Thermal Discharge from the Toledo Edison Bayshore Power Plant: An Update

Figure 2. Locations of Substrate Sampling in Maumee Bay

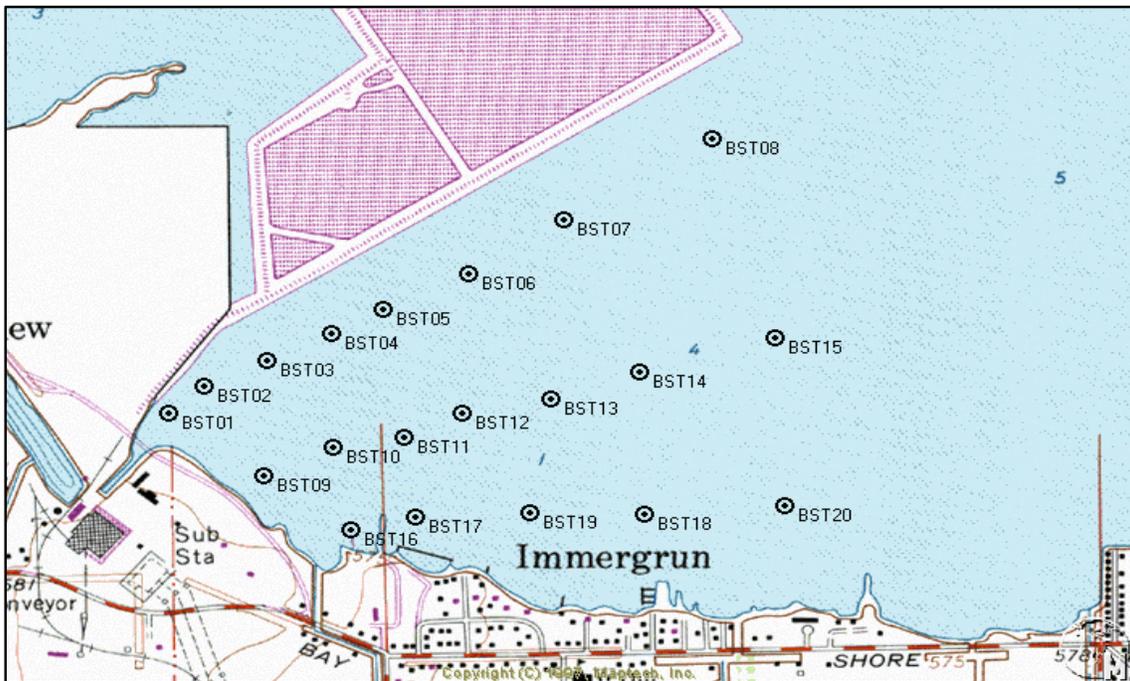
Table 1 below shows the characteristics of the substrate (or the material at the bottom) in Maumee Bay in the vicinity of the Bayshore Plant’s thermal discharge plume. Substrate samples were obtained during the summer of 2004. Locations of the sampling sites are shown on page 9 in Figure 2.

Based on bottom substrate grab samples collected during June and July 2004, it is apparent that the near-field thermal plume is resulting in the domination of the Asian clam *Corbicula*. Population densities of *Corbicula* increased at sites closest to the thermal discharge, and comprised the primary substrate at these sites. (See Table 1.)

Figure 5. Surface Temperature Contours for June 26, 2002 (in degrees Centigrade)

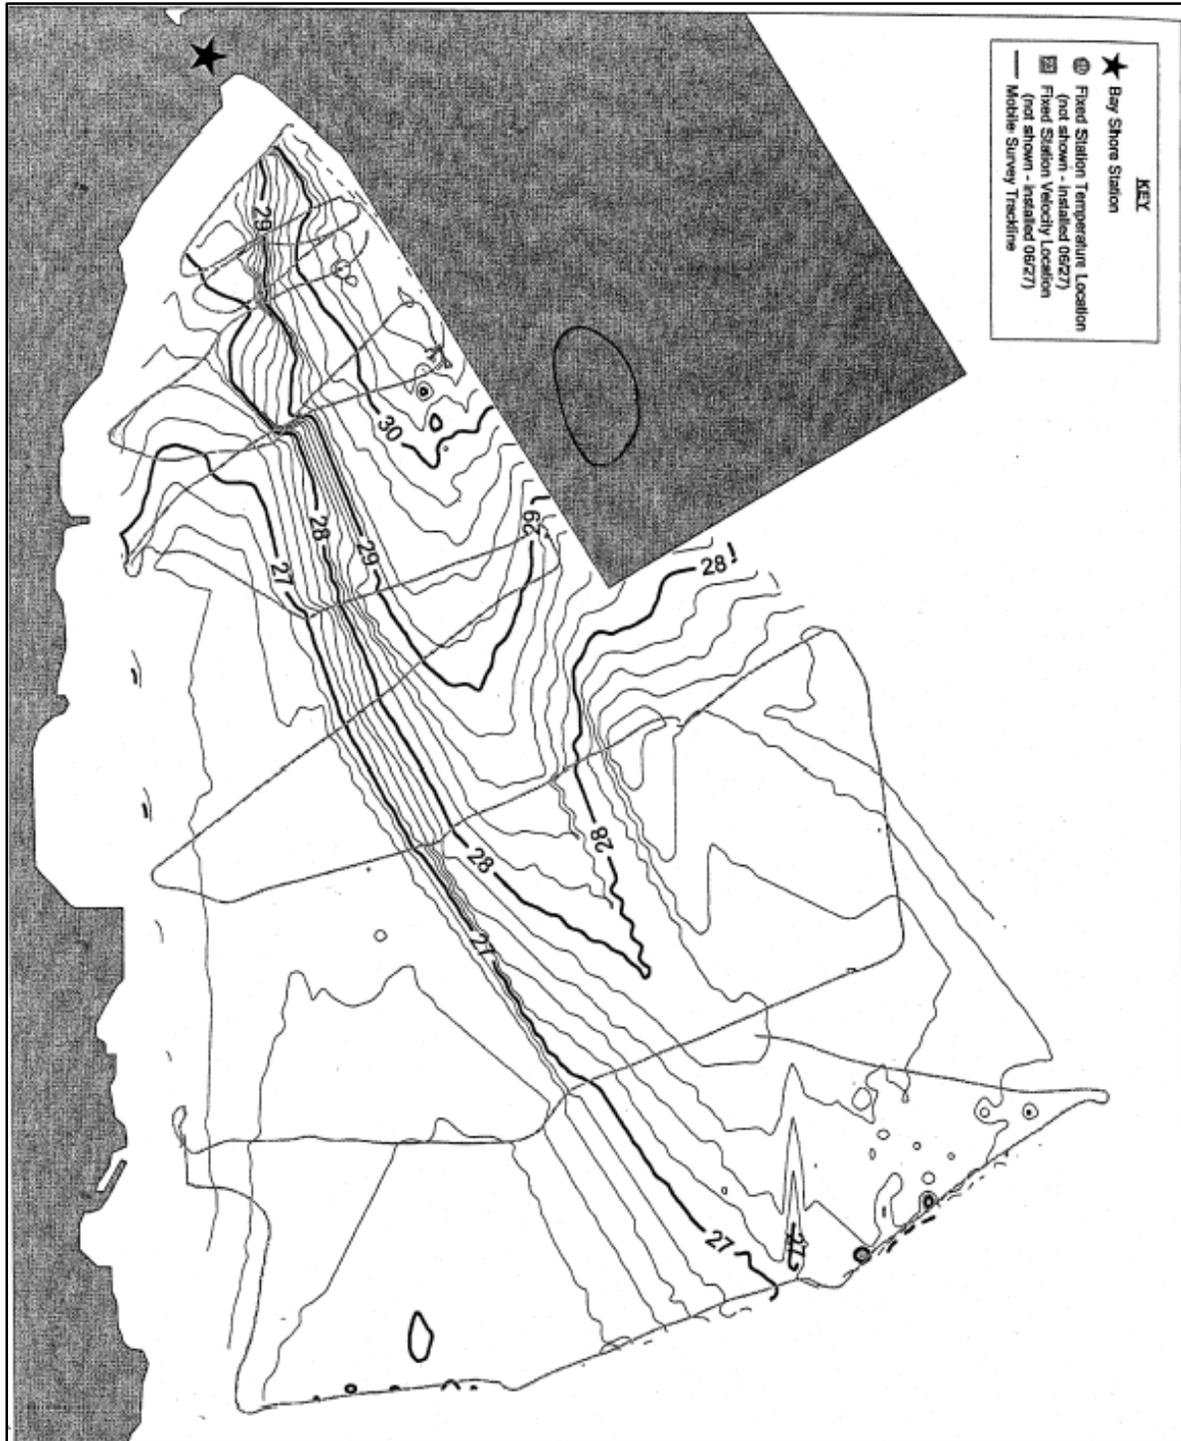
- Spatial distribution. The sampling performed during the summer of 2002 showed that the spatial distribution of the thermal plume is variable. On June 26th, the thermal plume extended in a northeasterly direction, parallel with the Confined Disposal Facility (CDF). (See Figure 5 in Attachment II.) On other occasions such as July 30th (Figure 7), the plume extended in a wider area to the south shore of Maumee Bay. At times, the plume also extended more than a mile beyond the end of the CDF. The spatial distribution of the thermal plume is undoubtedly affected by wind patterns and other phenomenon such as seiche effects (i.e., the naturally-occurring back and forth movement of water in Lake Erie and Maumee Bay, resulting in constantly changing water levels).
